Re: 750 Marlborough Avenue Warehouse Initial Study and Draft Mitigated Negative Declaration

**Mitigated Negative Declaration (MND) for the
Proposed Guthrie Industrial Warehouse
(Planning Cases P17-0506 (DR), P17-0507 (GE), P17-0748 (GE), and P17-0749 (VR))**

Response to Comments on the Draft IS-MND

Enclosures – Exhibits A- 1 through A-8

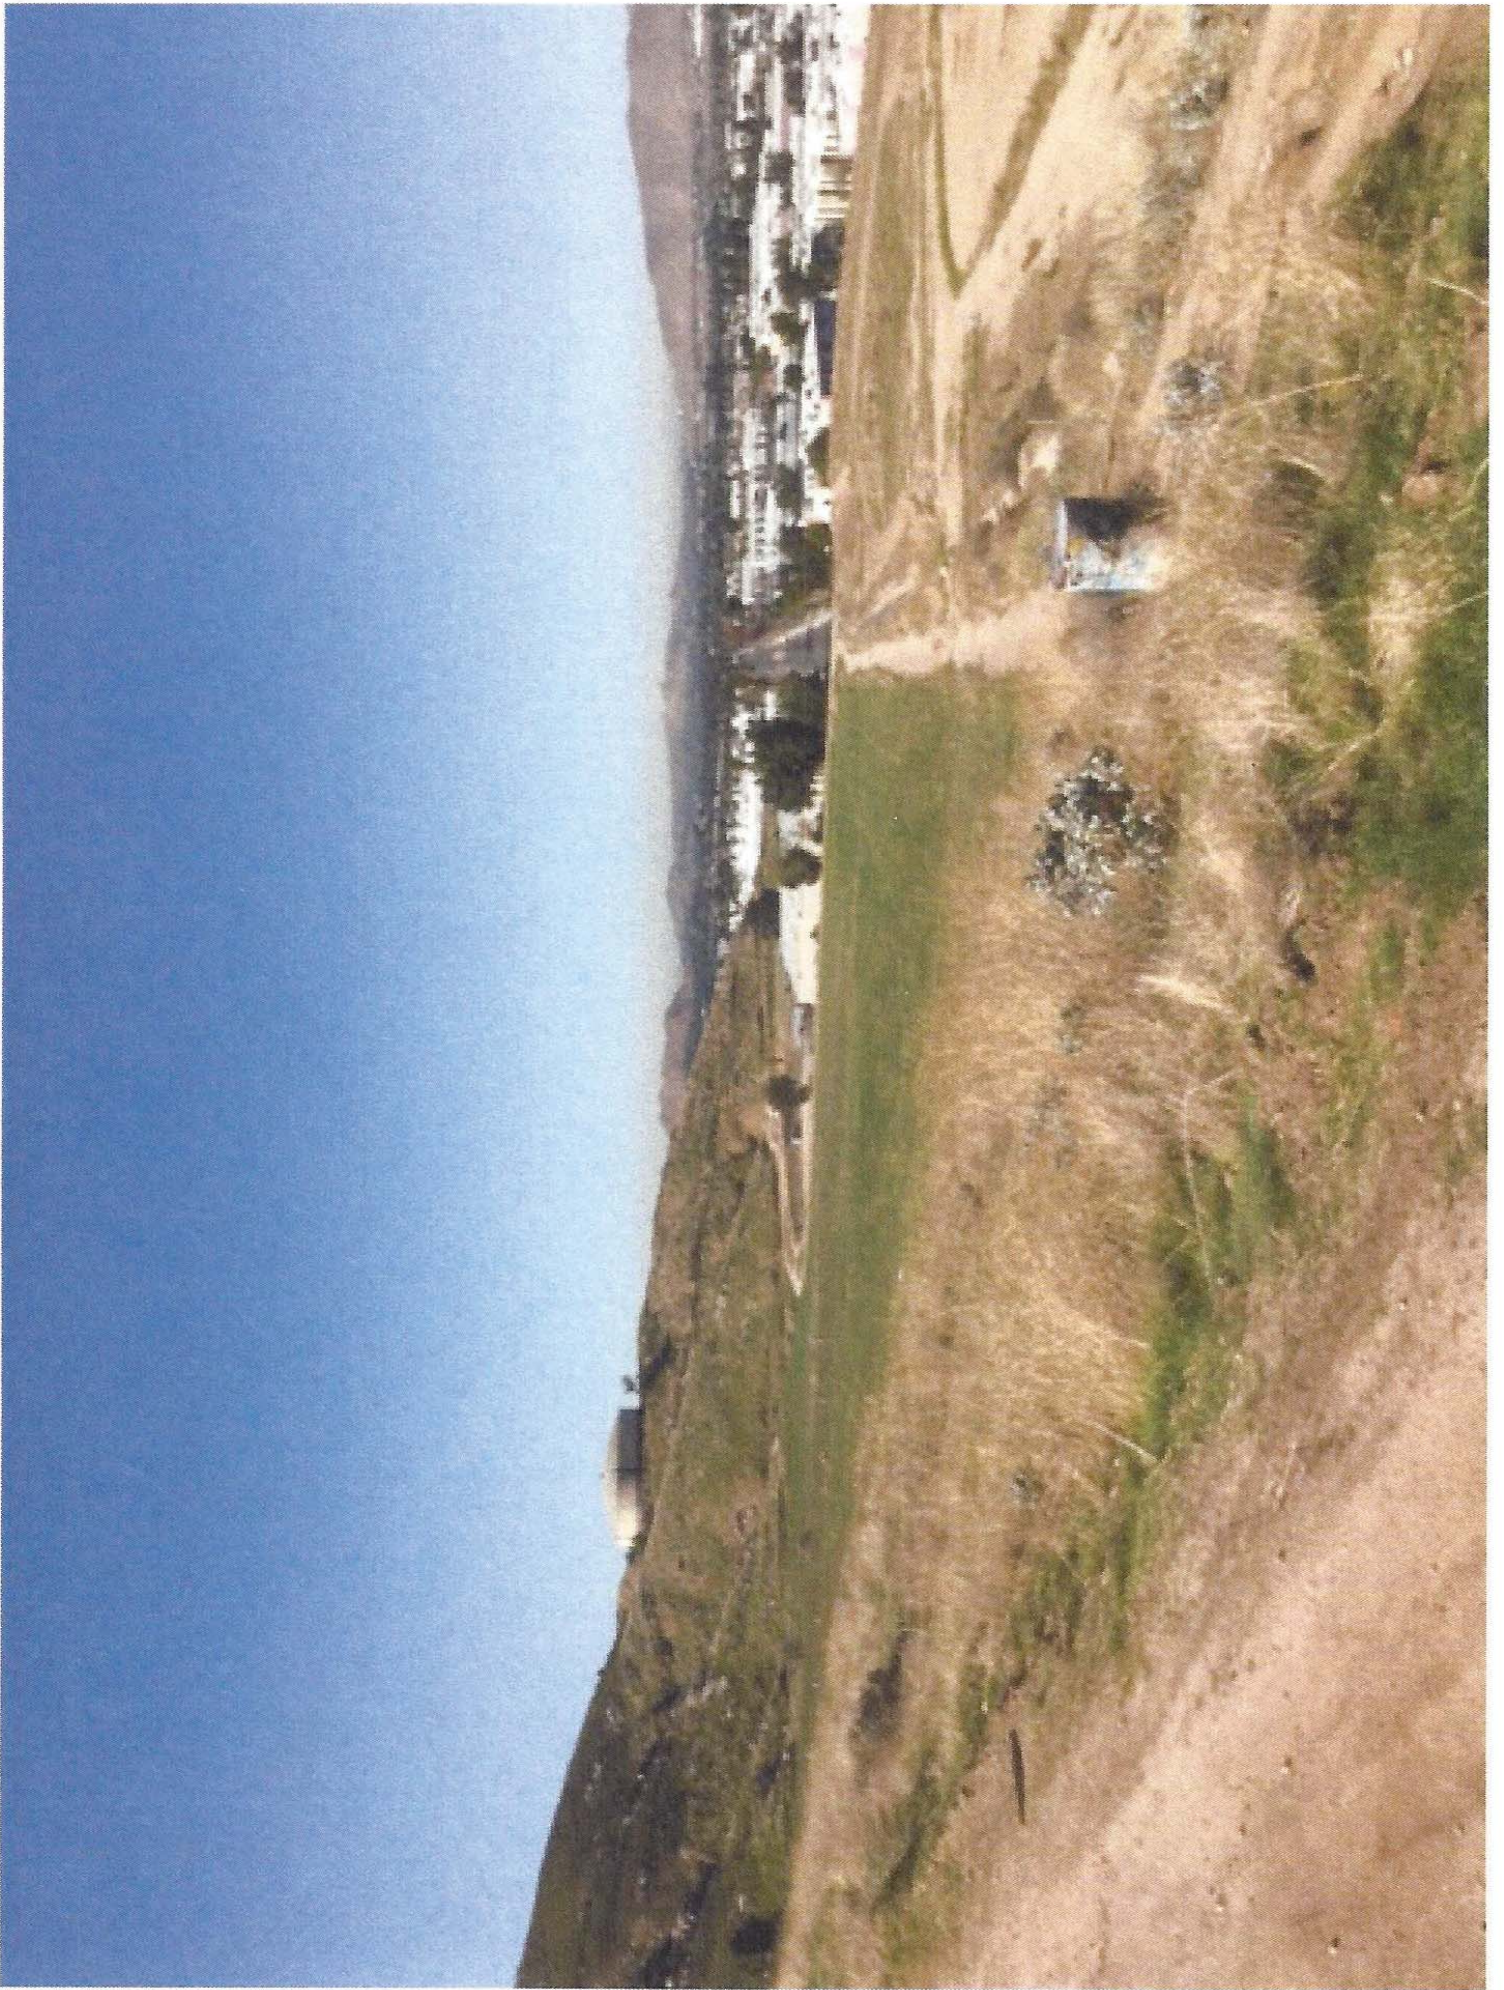
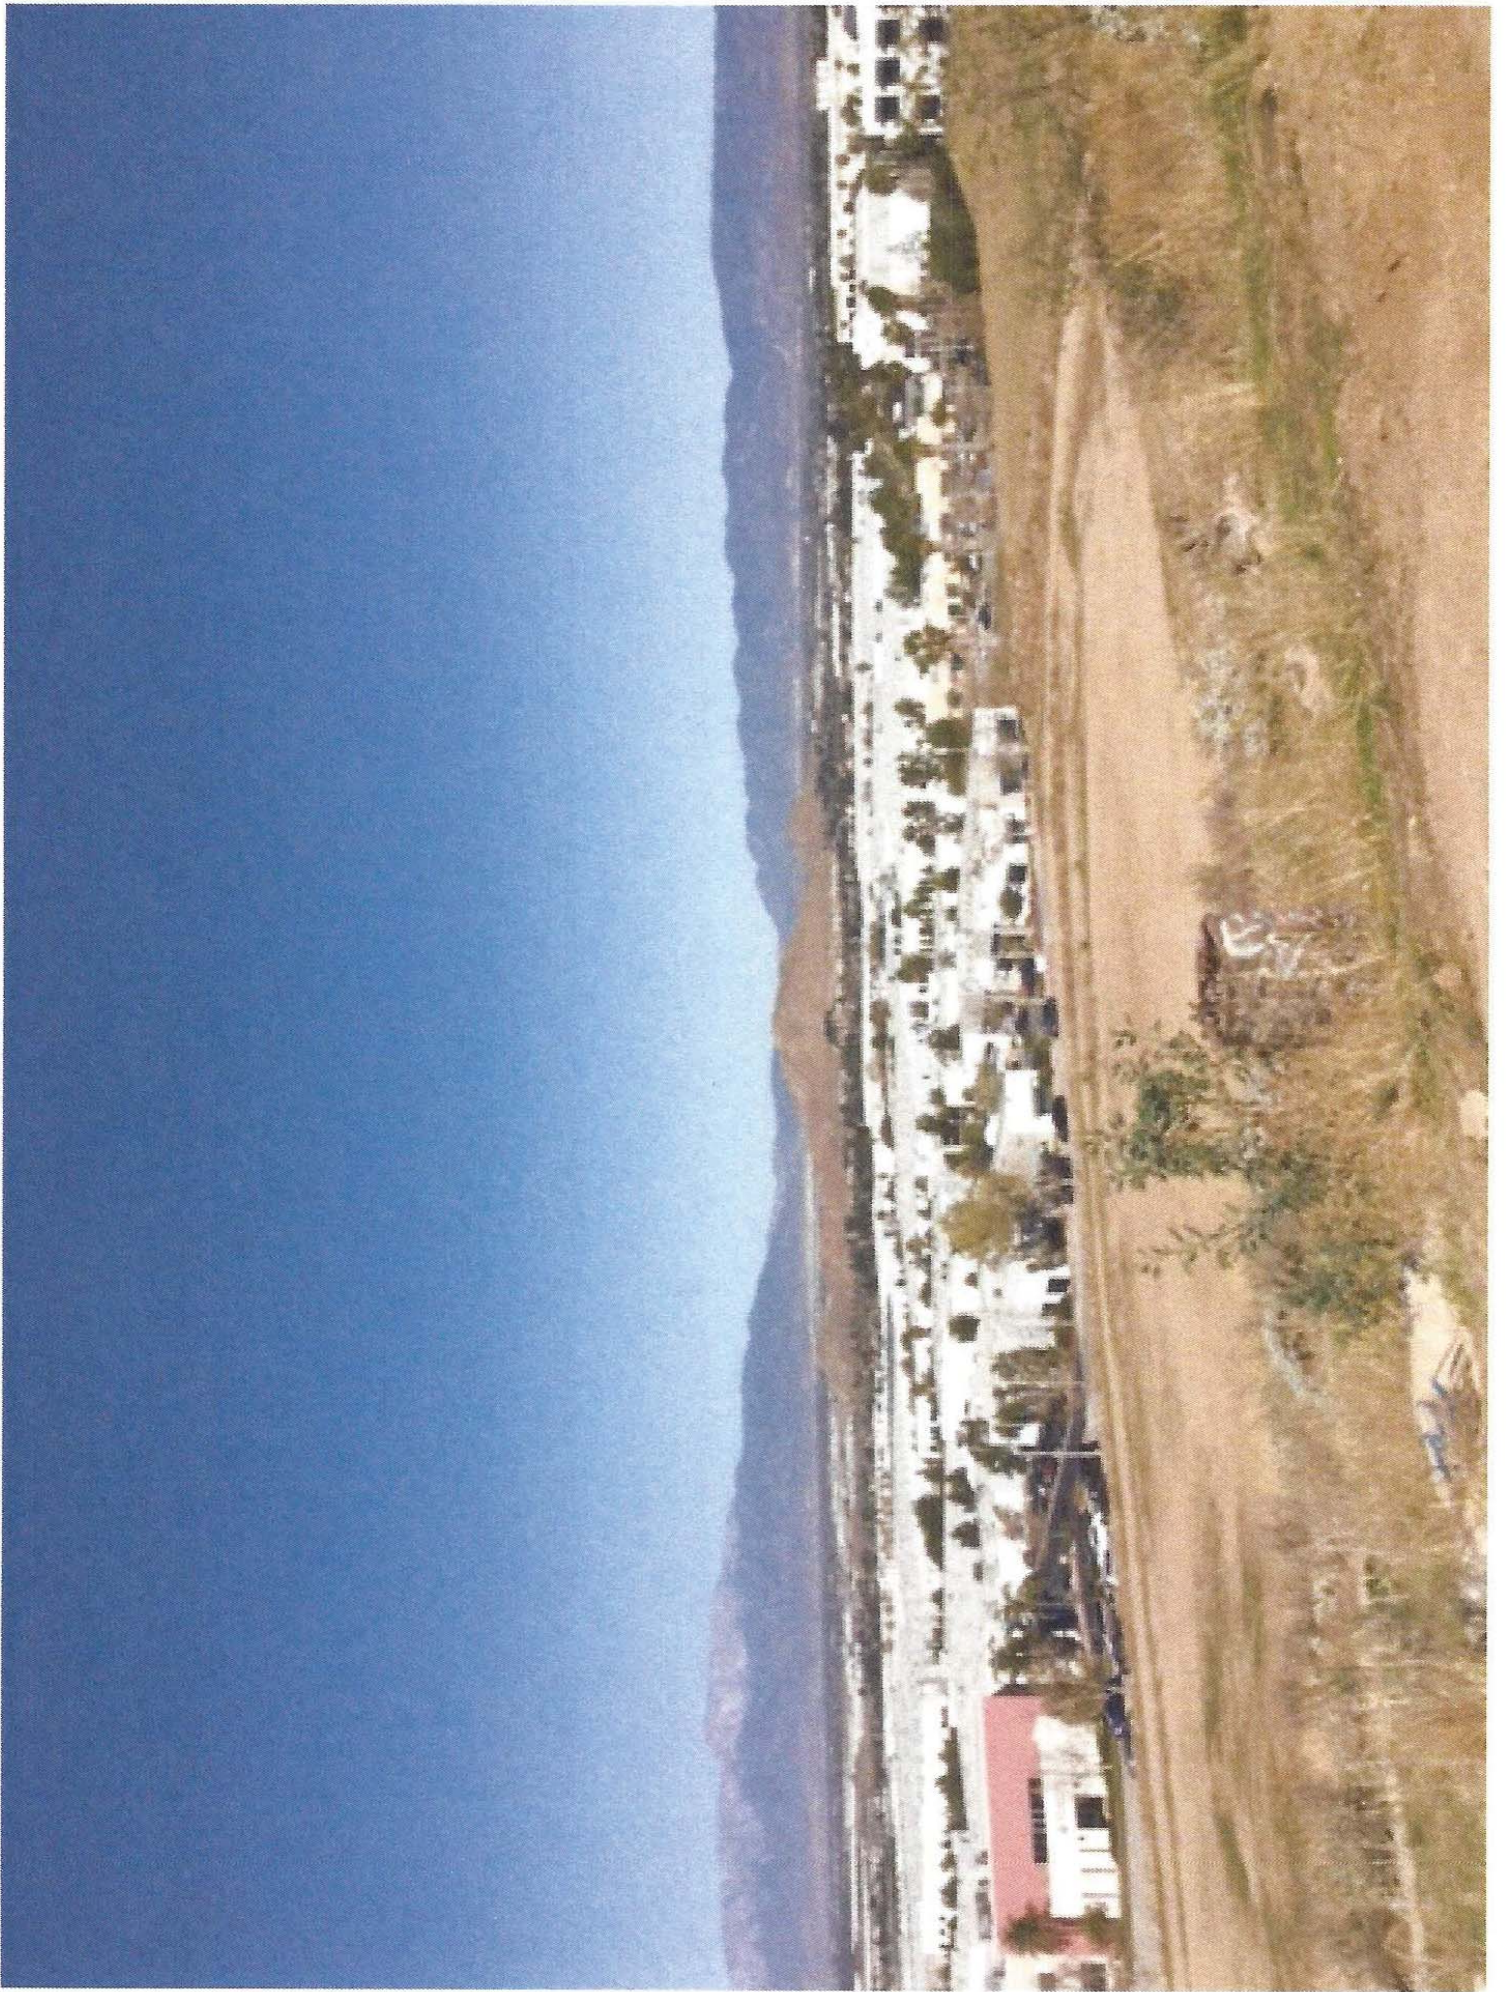
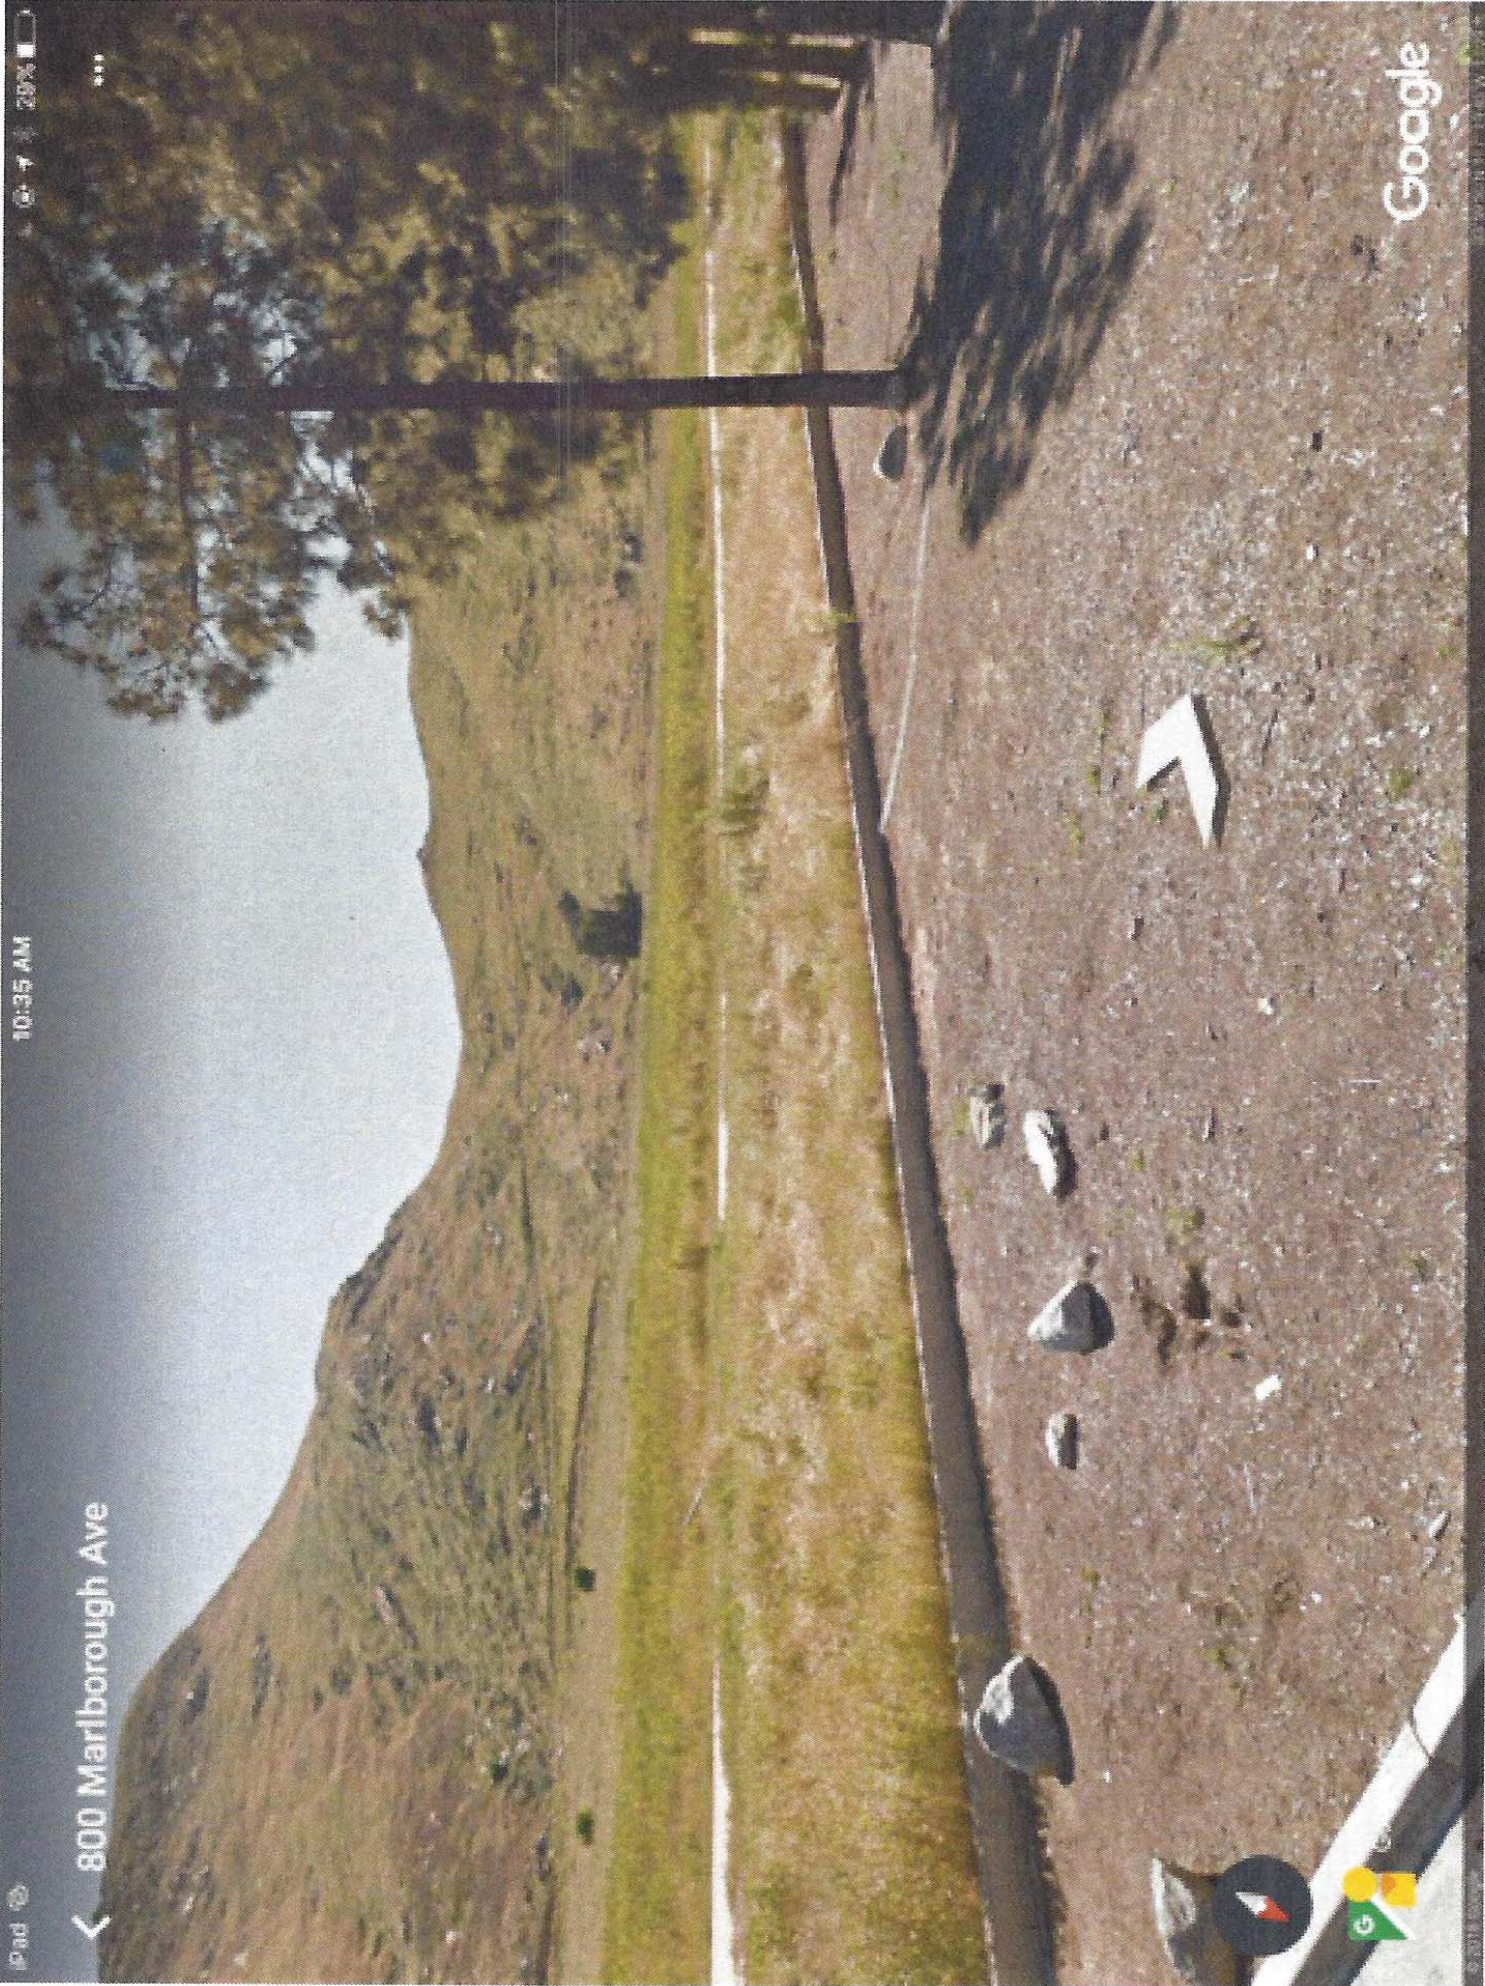
As for aesthetics, the views both of the Reserve and from the trails that lead to the Reserve will be permanently and adversely impacted by the Project's massive height (45') and size (340,000 sf). Exhibits A-1 and A-2 show the views from the bottom of the trail leading across the north side of the Project site to Marlborough Road. Views from this trail to the mountains far to the west are clear and will obviously be blocked entirely by the 45 foot-high warehouse.

Exhibits A-3 and A-4 show the views from the same location as in A-1 and A-2, but looking towards the San Bernardino Mountains. Again, these are incredible views, and part of the value of the Reserve as open space.

Therefore, the shabby analysis claiming there are no significant impacts to aesthetics due to the Project is simply untrue. These photos provide evidence of the impacts, and the 45 foot-high warehouse, the massive parking areas and loading docks, will have an adverse impact on the views of the Reserve and from the Reserve, which impacts cannot be mitigated to a level of insignificance.
